UNITED STATES PATENT AND TRADEMARK OFFICE

| APPLICATION NO. | FILING DATE | FIRST NAMED INVENTOR | ATTORNEY DOCKET NO. | CONFIRMATION NO. |
|--|-------------|----------------------|-----------------------------|------------------------|
| 10/510,111 | 10/04/2004 | Norihisa Hirota | Q84015 | 5058 |

Office Action Summary

DETAILED ACTION

FIG. 11

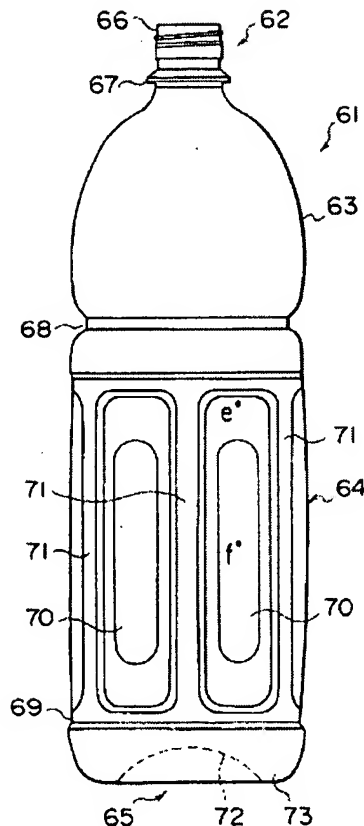
Regarding claim 1, Nakamaki ('420) teaches a heat-resistant polyester container (col. 1, ll. 13-19 and FIG-11, #64) with a barrel portion (FIG-11, #63).

The phrase **“wherein the temperature T is not lower than 120°C at a moment when the coefficient of contraction in the barrel portion of the polyester container represented by the following formula is 0.66%, Ratio of contraction (%) = (amount of contraction/gauge length) x 100 --- (1) wherein the amount of contraction is measured from a test piece cut from the barrel portion of the polyester container so as to possess a gauge length of 20 mm in compliance with TMA without pre-loading while elevating the temperature at a rate of 3°C/min. after 30°C is exceeded”** in claim 1, lines 1-8 is not given any patentable weight other than the “barrel portion”, as discussed above as Applicant has not precisely positively set forth any structural limitations of Applicant's product.

Regarding claim 2, Nakamaki ('420) teaches panels in the barrel portion (FIG. 11, #70 and #64).

The phrase **“the coefficient of contraction and the temperature T are values at pole portions among the reduced pressure-absorbing panels”** in claim 2, lines 2-4 is not given any patentable weight as Applicant has not precisely positively set forth any structural limitations other than those discussed above.
